Docket Item # 11
BAR CASE # 2008-0159

BAR Meeting
October 1, 2008

ISSUE: Addition/Alterations
APPLICANT: Karl and Lydia Svoboda
LOCATION: 113 Princess Street
ZONE: RM/Residential

Figure 4. Proposed front (south) elevation with projecting bay window and dormer.

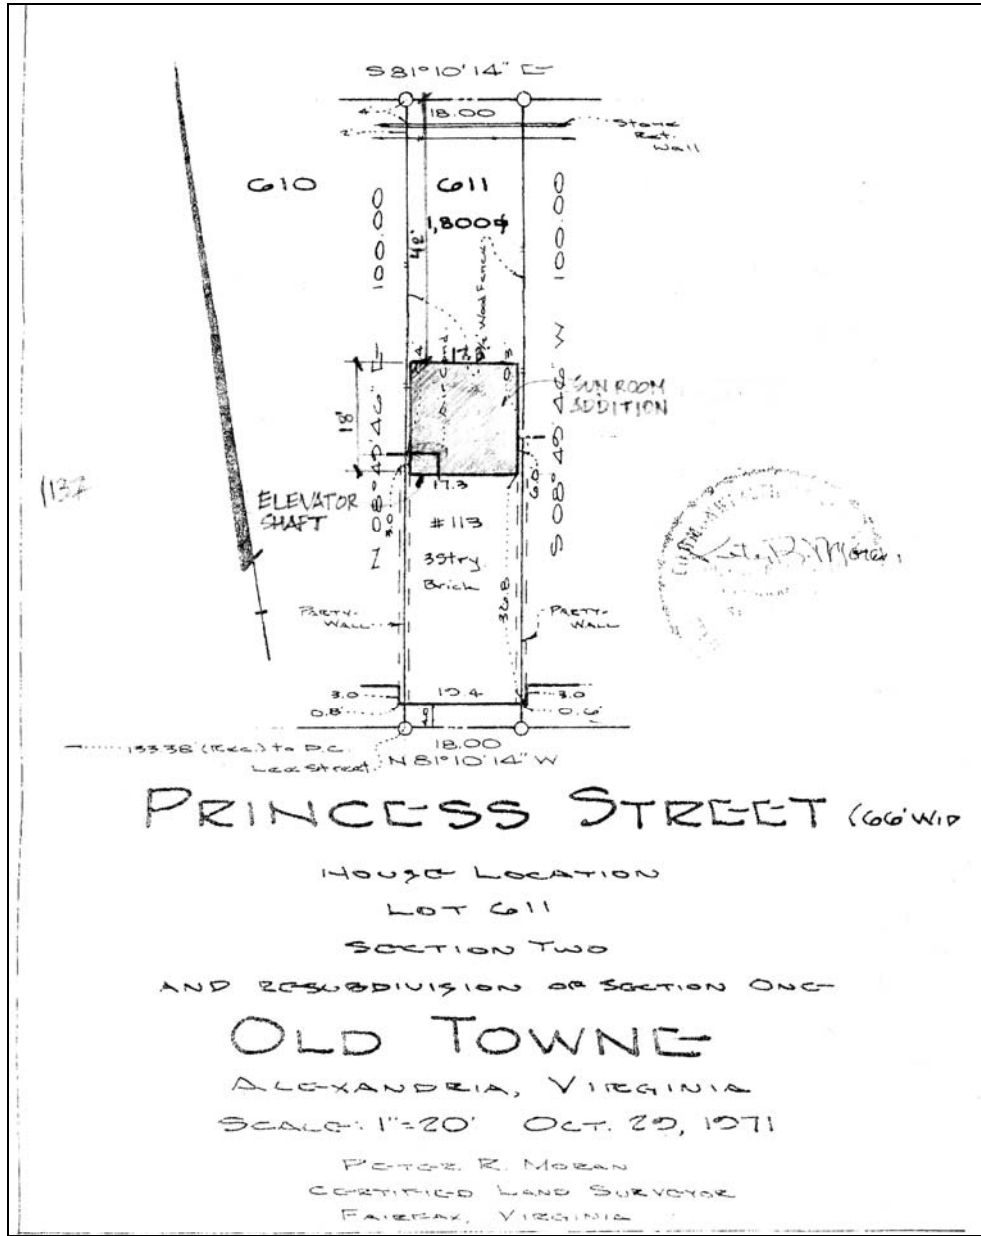
1. That the applicant reevaluate the design of the front dormer to lower the height below the existing roof ridge height and work with Staff for final approval;

During the past several years the Board has reviewed a number of substantial alterations and additions to the properties within this development that include the addition of bay windows at the second story and the addition of dormers at the roof. Staff finds that historic fabric is not lost to accommodate the alterations and that the proposed alterations are generally in keeping with the Colonial Revival style of these townhouses. Staff is concerned about the height and appearance of the proposed dormer on the front elevation. Staff finds that a dormer is acceptable at this location but recommends that the height of the dormer not exceed the existing roof ridge height. Staff finds that this would best be accomplished by reevaluating the proposed gable and height over the center window.
